LICENSEE EVENT REPORT (LER)

FACILITY NAME (1) CRYSTAL RIVER UNIT 3	DOCKET NUMBER (2) 0 5 0 0 0 3 0 2	PAGE (3) 1 OF 0 8
--	--------------------------------------	----------------------

TITLE (4) **Broken Stem Nut in "B" Feedwater Main Block Valve Results in a Feedwater Transient and a Subsequent Reactor Trip**

SPECIAL ATTACHMENT TO LER 88-006

FIGURE I

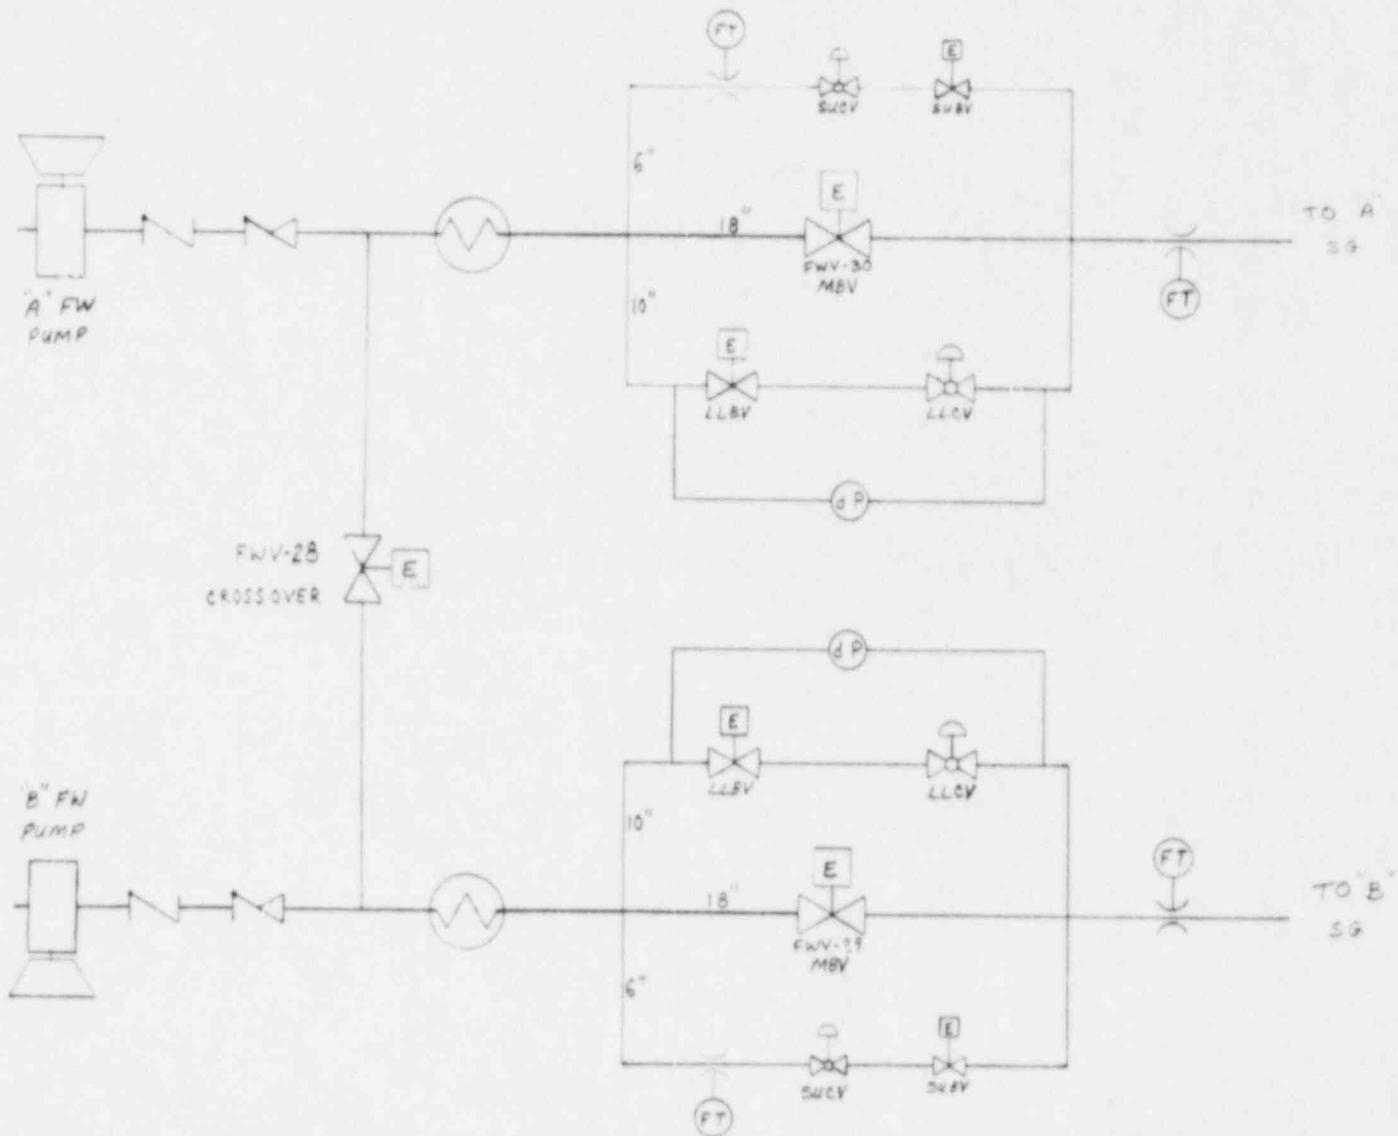
5. Q - Provide P&ID's for the MFW system and ICS system schematics.
A - Figure #1 of LER 88-006 shows the arrangement of the FW valves. Item #1 describes the ICS control of FW from 0% to 100% power. Additional drawings have been provided to the Project Manager.
